April 24, 2008

**Re: GE-Pittsfield/Housatonic River Site
Unkamet Brook Area (GEC170)
Second Supplement to the Pre-Design Investigation Report for Unkamet Brook Area
Removal Action**

Accordingly, GE has prepared this *Second Supplement to the Pre-Design Investigation Report for Unkamet Brook Area Removal Action* (Second Supplement) in response to the above referenced March 26, 2008 EPA conditional approval letter. In addition to responding to the conditions specified in that letter, this document summarizes the results of additional supplemental PCB investigations conducted by GE within the southernmost portion of the Unkamet Brook Area and proposes additional activities to be performed in that area.

NOTES:

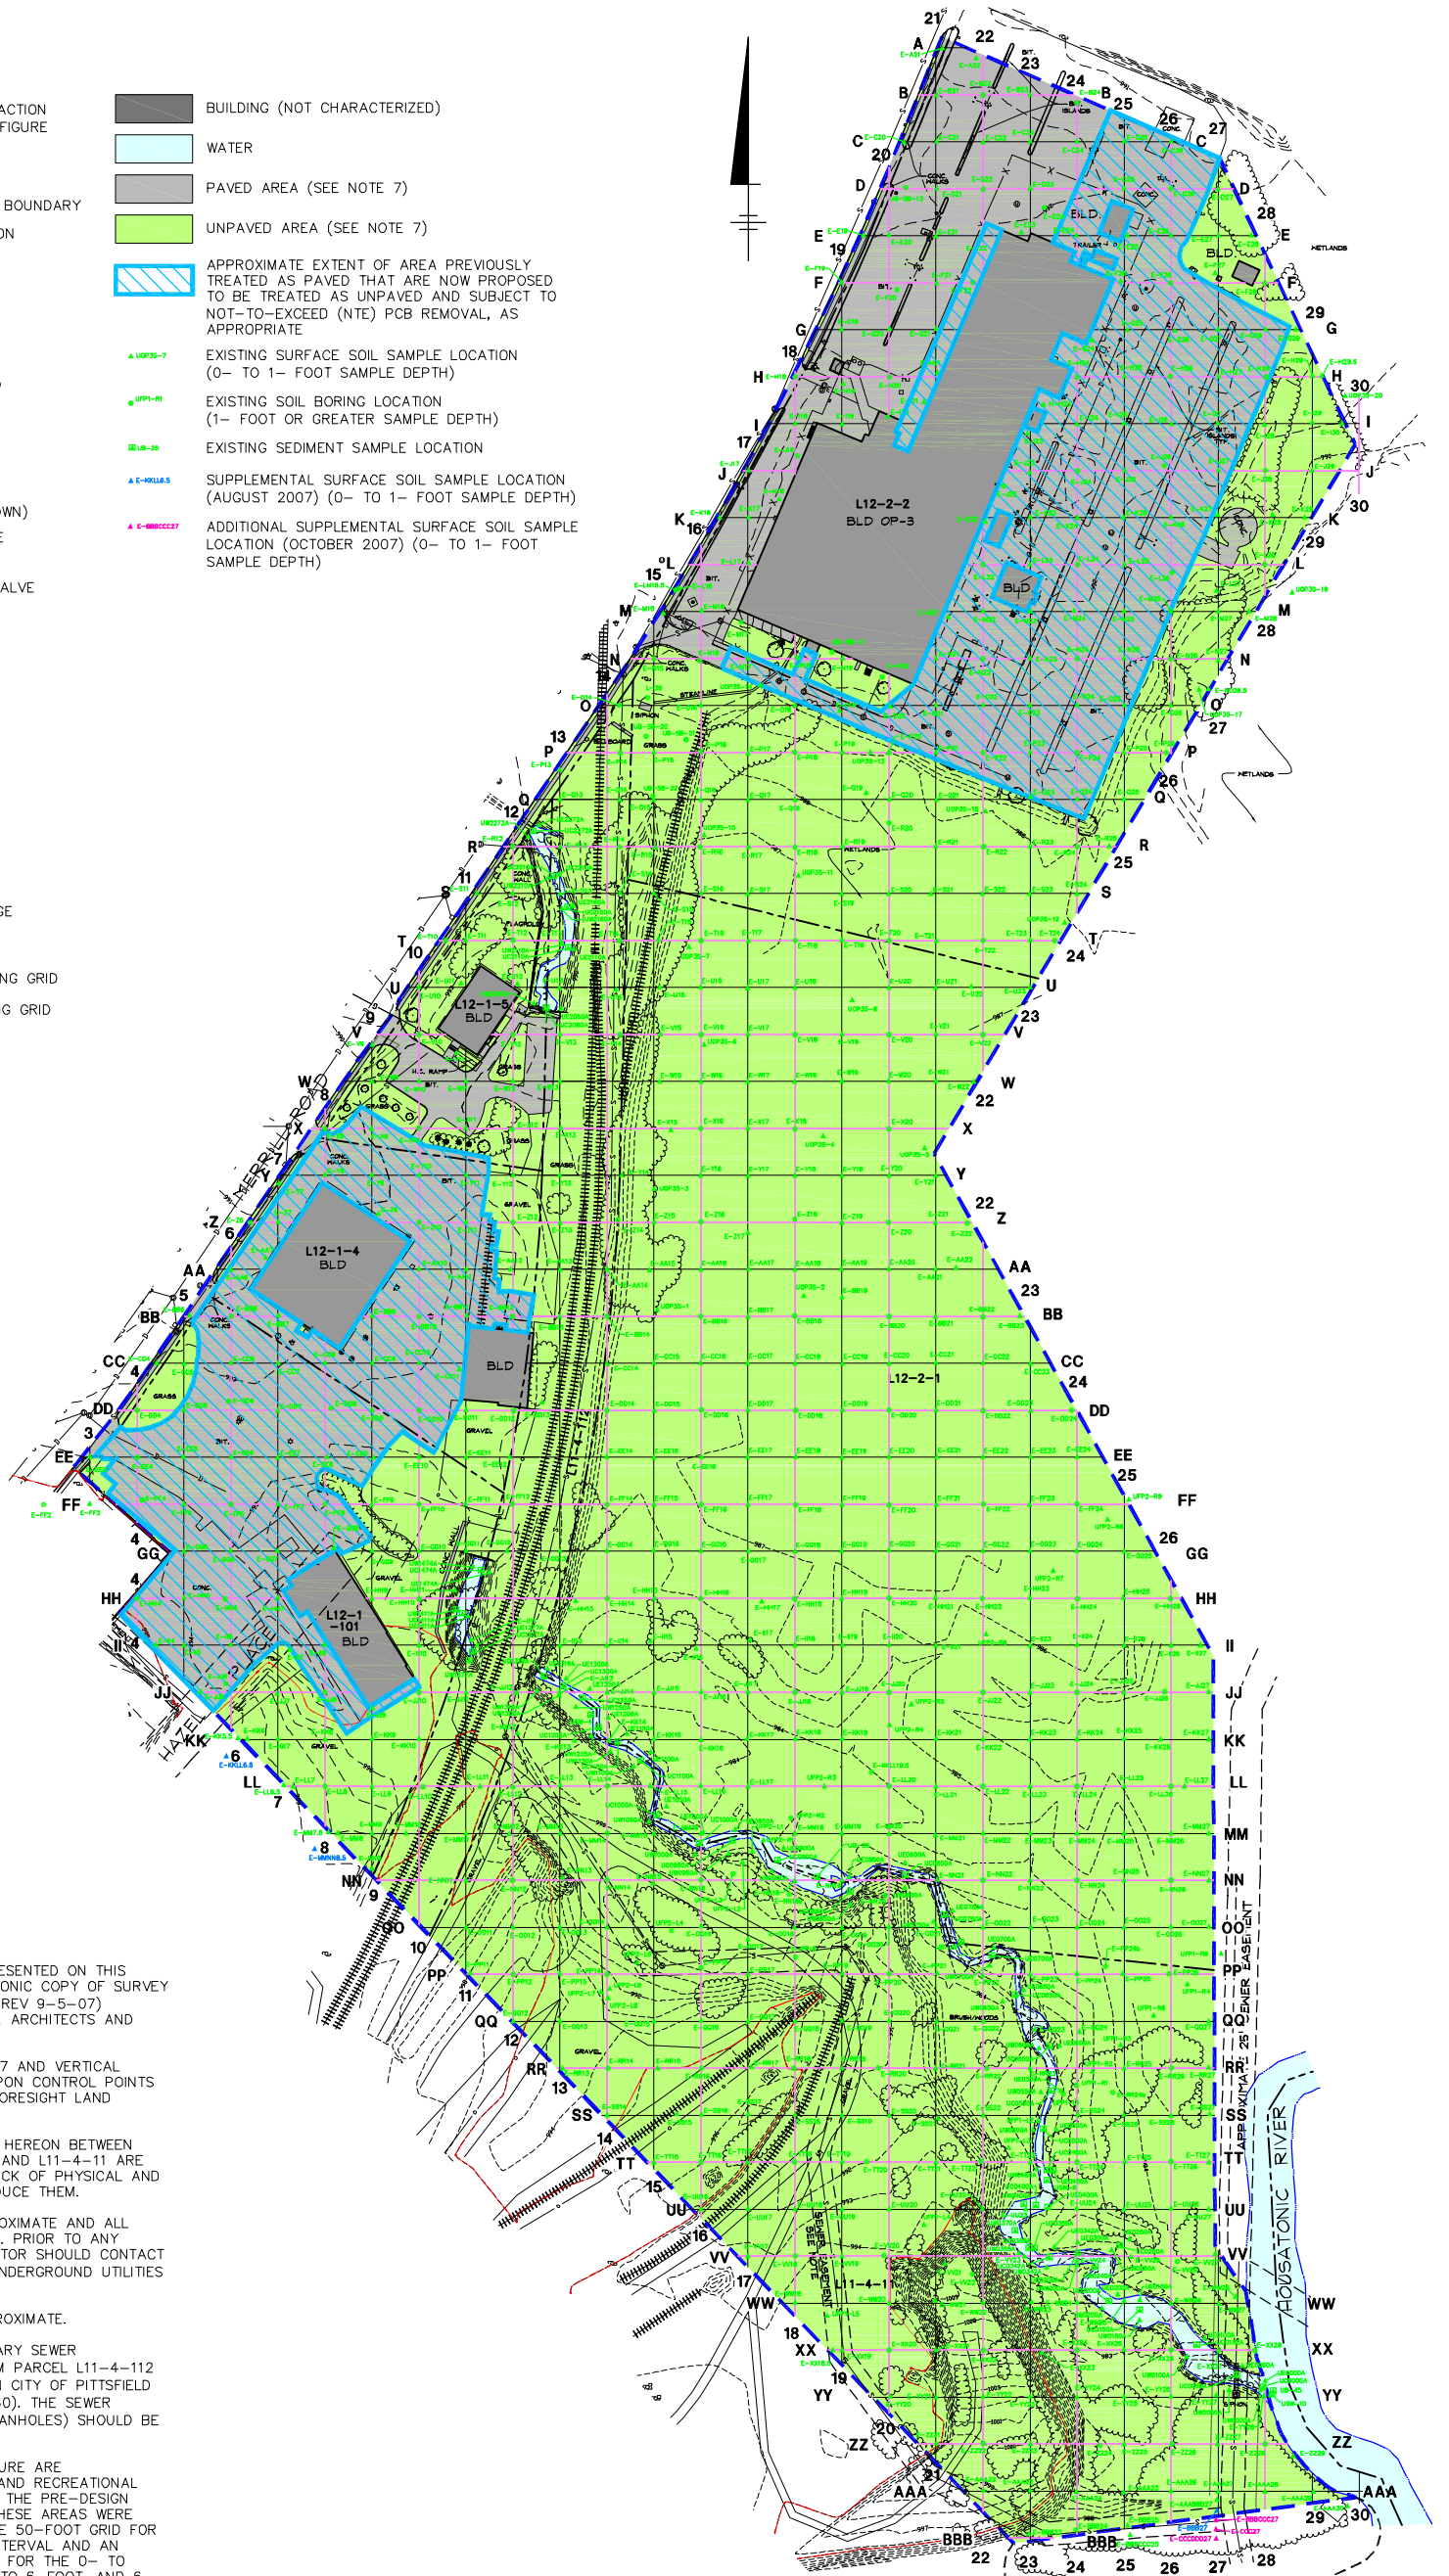
- With regard to the area designated by EPA as “unpaved” (green hatched area on EPA Figure 2) south of Building 51 at GE-owned Parcel K12-9-1 (see Figure B attached), GE proposes to treat this area as unpaved. Additional characterization sampling within this area is not required because, although a 100-foot grid node does not fall within the area (Figure B), adjacent 100-foot grid soil borings N-NN10 and N-NN12 are located on either side of this area and satisfy characterization requirements for this area on an unpaved sampling basis. Moreover, no not-to-exceed (NTE) PCB concentrations exist within the 0- to 1-foot depth increment in this area, and, therefore, no additional removal is required; and

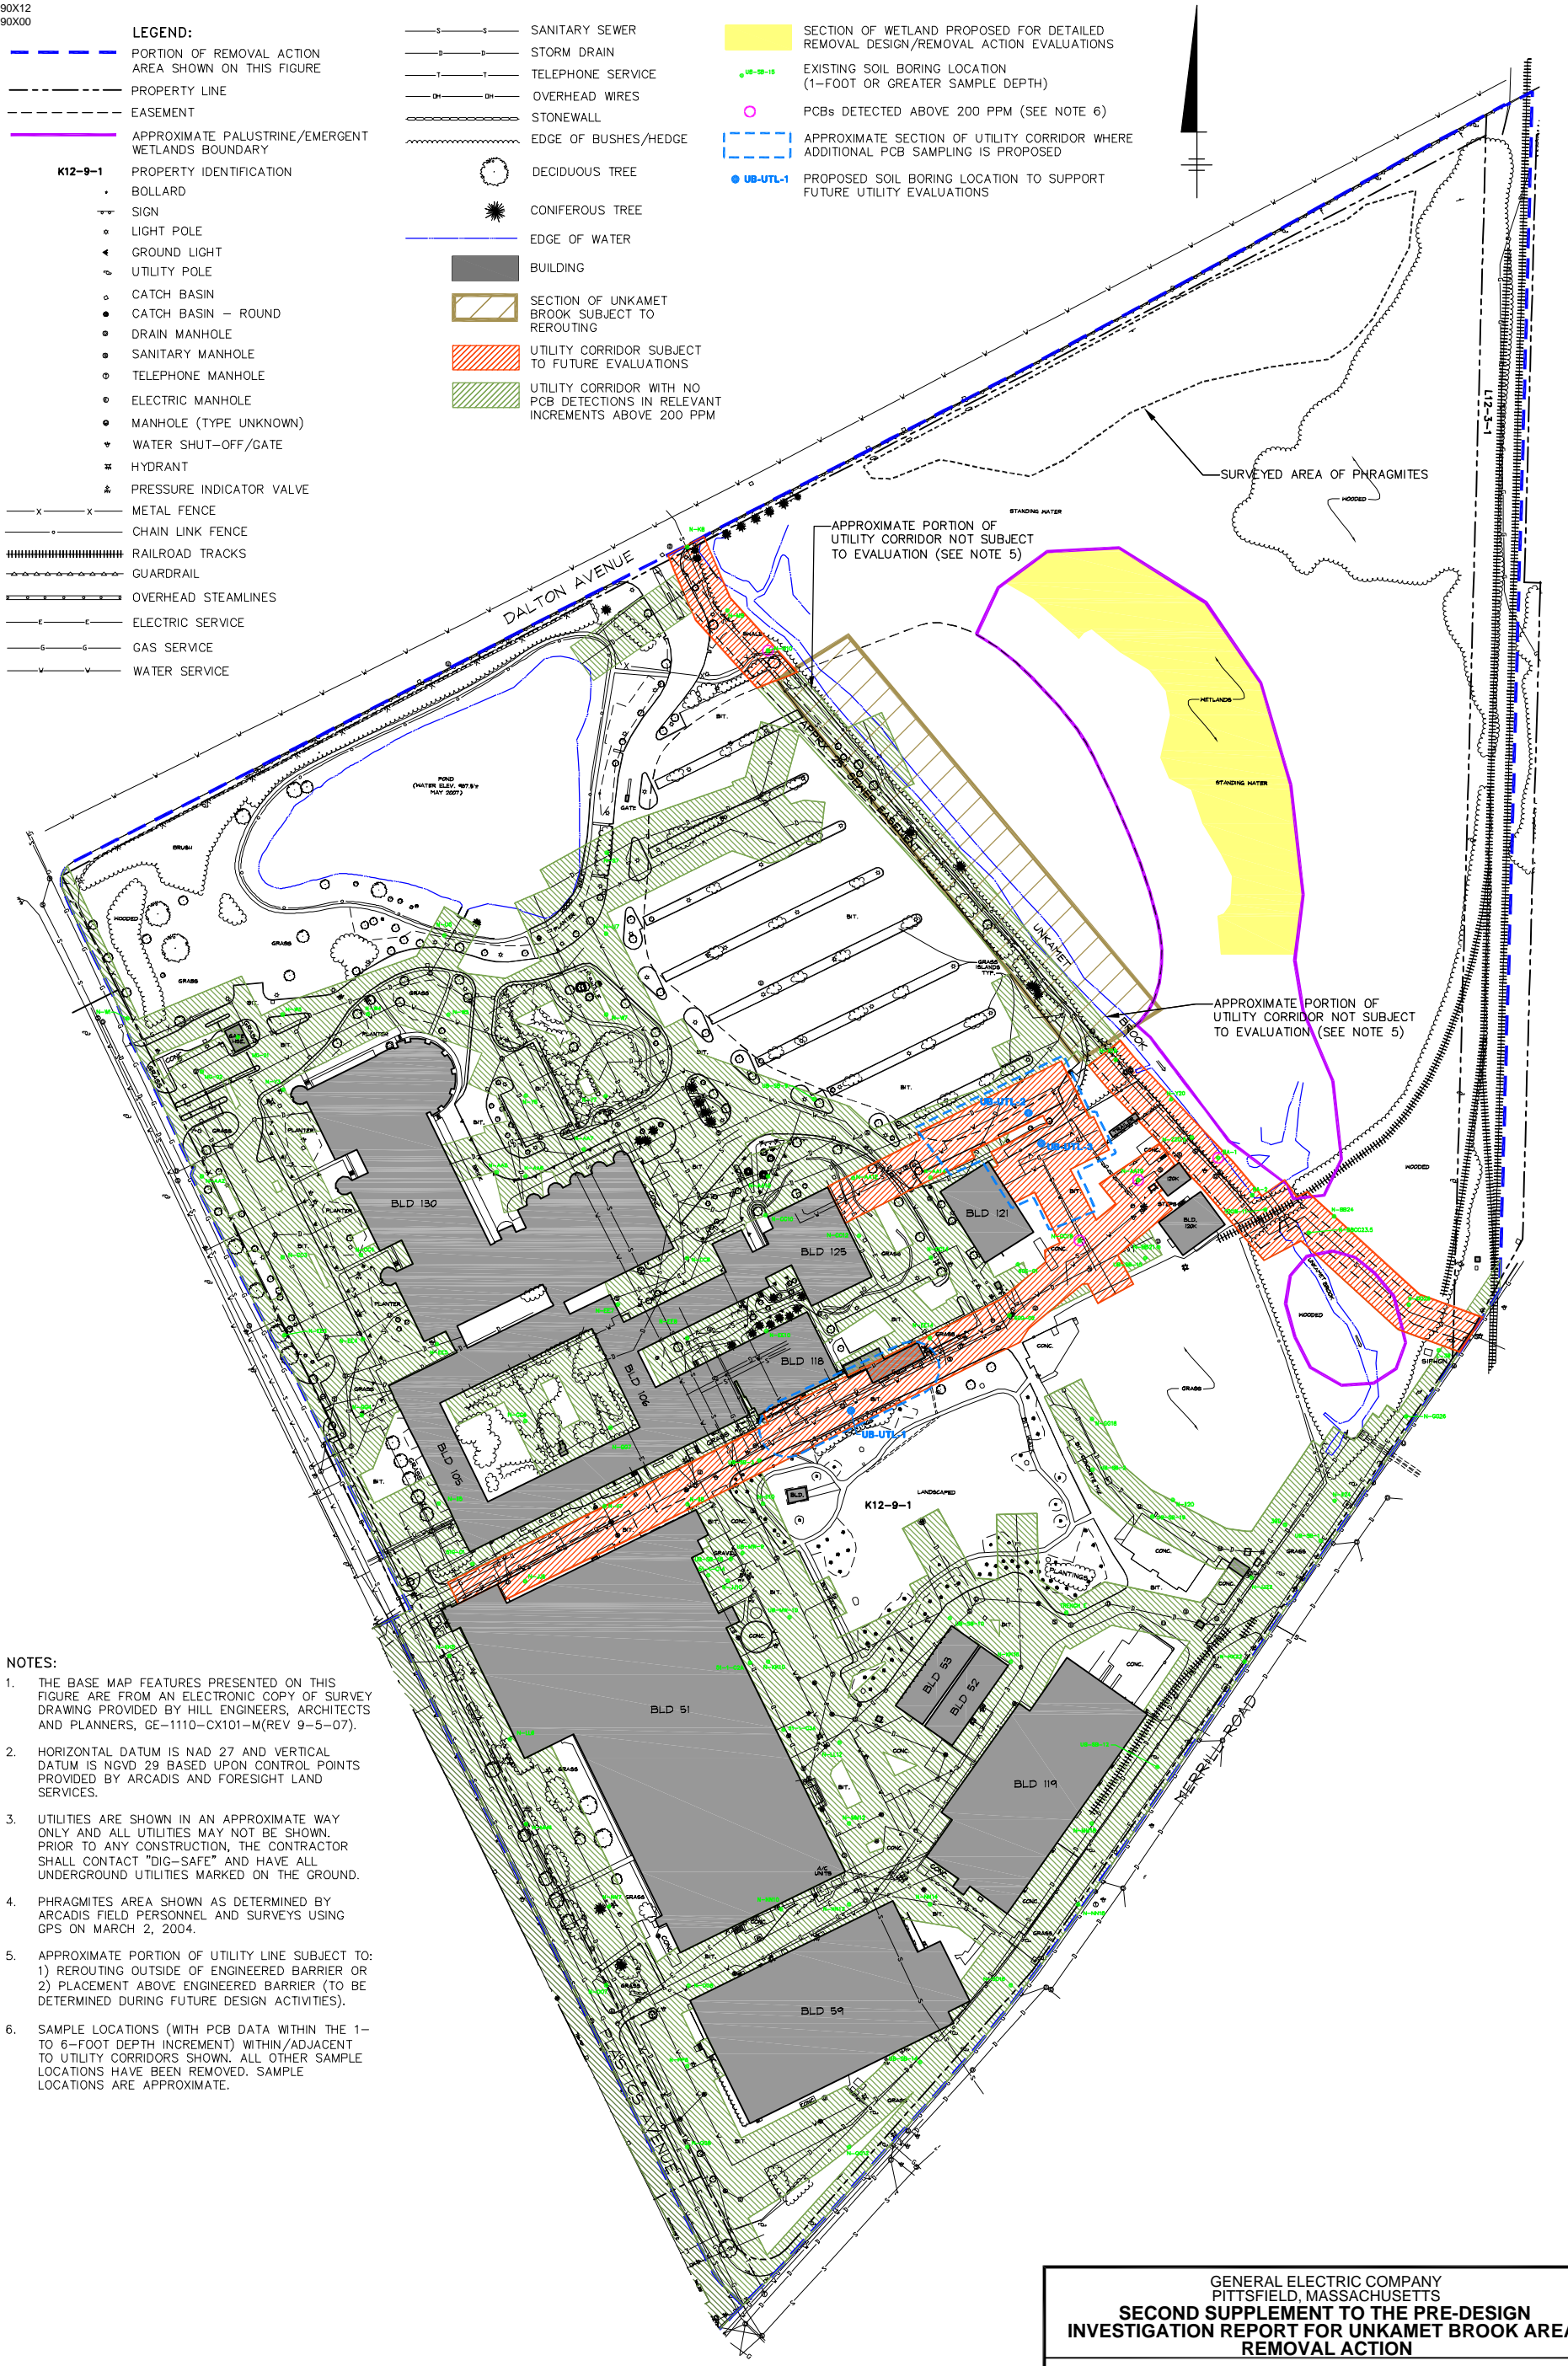
EPA Condition 3 – GE shall submit revised figures in the Second Supplement that accurately depict the location of all utility lines and all utility corridors in the Removal Action Area. All utility lines that have been surveyed shall be depicted on the revised figures at their surveyed locations. GE shall evaluate each utility corridor to ensure that each has been characterized pursuant to the characterization methods for utility corridors specified in Section 2.6.1.7 of the Pre-Design Investigation Report. If necessary, GE shall propose additional sampling to comply with these characterization methods for the evaluation of existing utility corridors.

GE Response – GE has prepared figures that depict the location of all utilities in the RAA based on the results of survey activities performed by Hill Engineers Architects and Planners (Hill) on behalf of GE. In accordance with the above condition, GE has also developed utility corridors associated with the utilities identified by Hill. Utility-related information is provided in Figures D through F of this document. Please note that the data summary discussions provided in response to this condition (as well as the information provided on Figures D through F and Tables 3 through 5) generally correspond to the appropriate utility-related evaluation depths for specific properties (i.e., 1- to 6-foot depth increment for GE-owned commercial/industrial properties and non-industrial area within Parcel K12-9-1 and 0- to approximate depth of utility bedding for the remaining properties not owned by GE).

The PDI Report identified several PCB analytical results above 200 ppm within certain utility corridors at the former North Area. PCB analytical results collected within the applicable utility-related depth increments and corridors within the former North Area are summarized on Table 4. As shown on Figure E, GE is proposing to conduct additional PCB sampling in certain utility corridors located adjacent to Building 121 that extend south of Building 118 towards Plastics Avenue to satisfy the 100- to 150-foot soil boring spacing requirement. Once the proposed sampling activities have been completed, the Conceptual RD/RA Work Plan for Unkamet Brook–West will include a utility evaluation associated with the above-referenced corridors adjacent to Building 121. In addition, the Conceptual RD/RA Work Plan for Unkamet Brook–Remainder will include a utility evaluation associated with the sanitary sewer line extending from Dalton Avenue to Merrill Road (Figure E). As previously indicated, utility corridors where PCB concentrations were not identified above 200 ppm (see green hatching on Figure E) do not require further evaluation.
